Waterside Residents Association

Mandurah Estuary Bridge Duplication Project

WE'RE FOR THE BRIDGE

March 2024

What About The Noise? – We're already well over the limit!

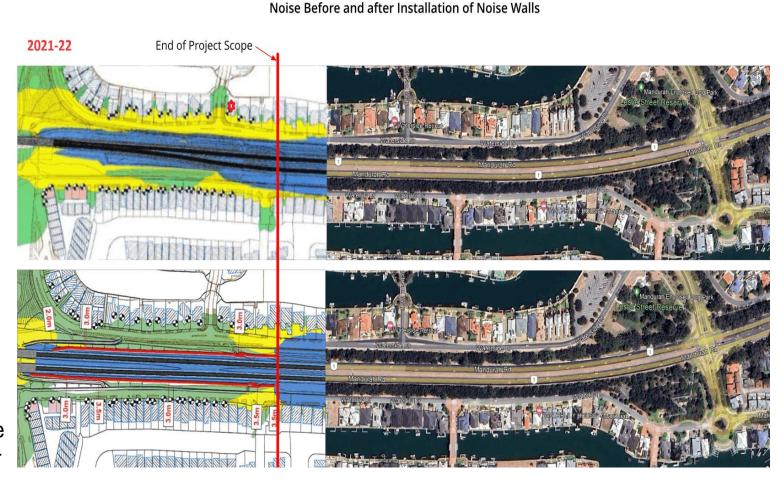
Vegetation 3-5dB End of corridor balloon effect!

SPP5.4 – states:

55dB = Night max

60dB = Daytime max

85dB = Ear muffs are legal requirement for workers.

* 36 Waterside Dr Wed 20/3/24 11am

Noise Before and after Installation of Noise Walls

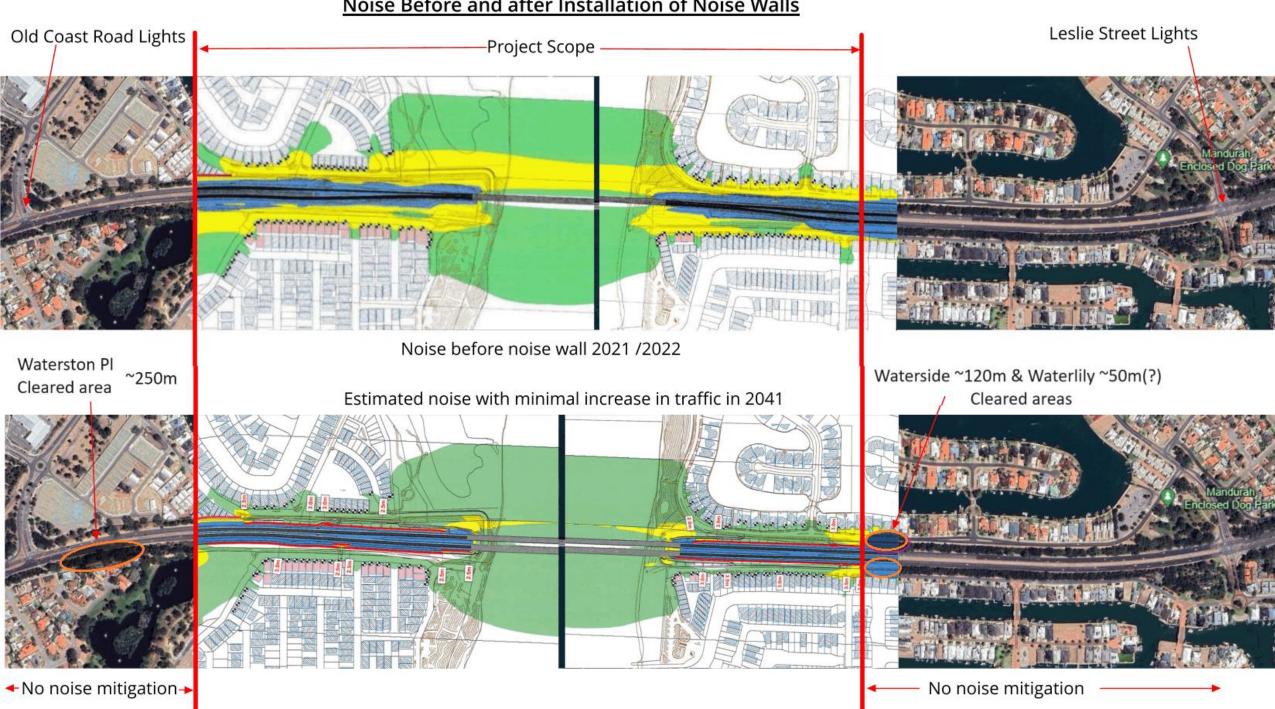
What's the Current Plan – West End (Erskine) (85%)

- Noise wall currently stops at orange arrow orange oval area already cleared
- No noise protection for houses in orange box
- Can now see directly into back yards *

West Side (Halls Head/Erskine) - What we're asking for!

- Continuation of planned noise wall on top of planned retaining wall red lines
- Current project wall stops at orange arrow (Option 1 starts at red arrow ~250m)
- (Note blue line is existing cycle path, pink line is new 4m wide cycle path)

East side (Dudley Park) - What we're asking for - Walls

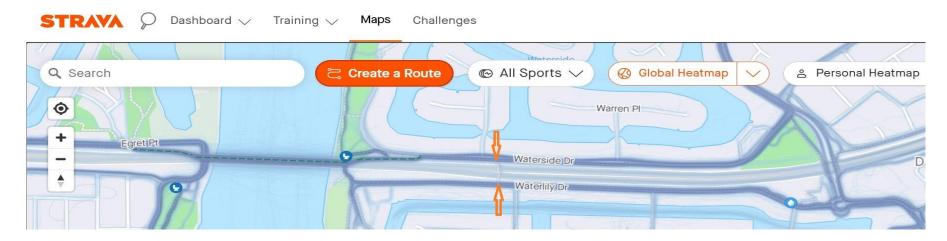
What's the Current Plan – East End (Dudley Park) (85%)

- Noise wall currently stops at orange arrows
- Orange ovals land already cleared ?? about to be cleared
- Cycle entry/exit points moved to end of current wall

- Continuation of planned noise wall red lines
- Removed cycle entry/exit paths at orange arrows
- (Note blue line is existing cycle path)

What We're Asking For – Cycle track improvement

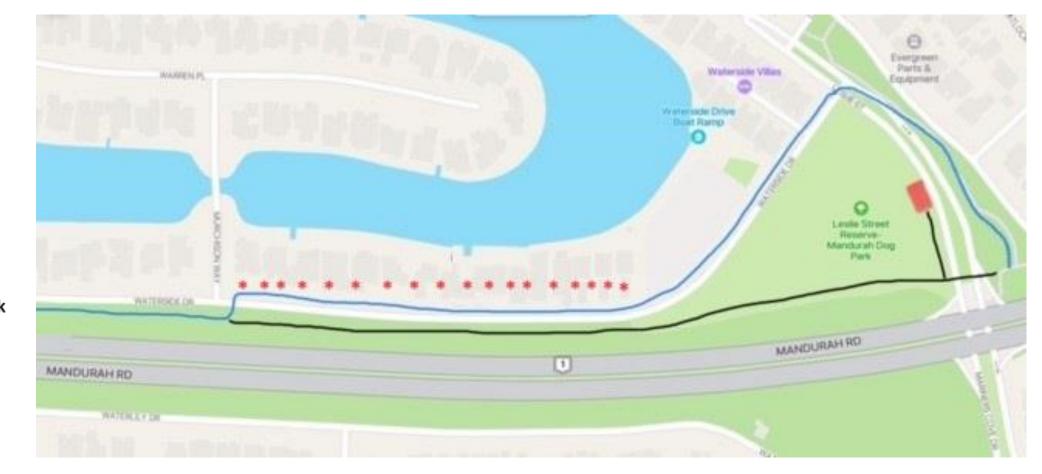
- *Currently needs two people to enable residents to reverse out of driveways with trailer/boat/van!
- * Most A&E cyclist arrivals are from driveway incidents plus now kids on electric scooters!

Current track

Proposed track

What We're Asking For – Vegetation

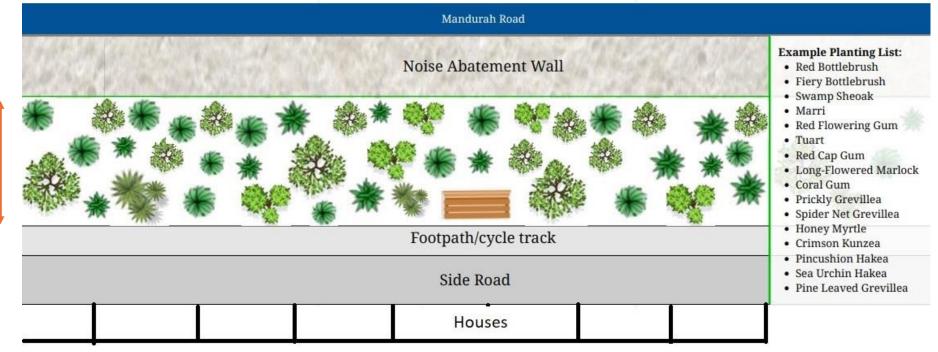
We want our small birds back

In consultation with City of Mandurah
